Studebaker

SERVICE BULLETIN

NO. 220

1949

**REAR FENDER WELT FOR PICK-UP
MODELS - 2R5, 2R10, 2R15**

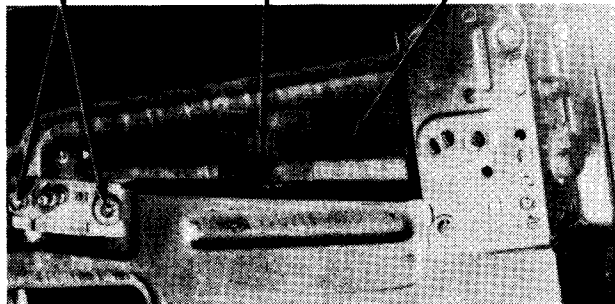
It is possible that mud or water may splash between the rear fender and the pick-up box on 2R5, 2R10, and 2R15-121 model trucks.

This condition can be corrected by installing a rear fender welt, Part No. 652939, between the fender and the pick-up box on each side.
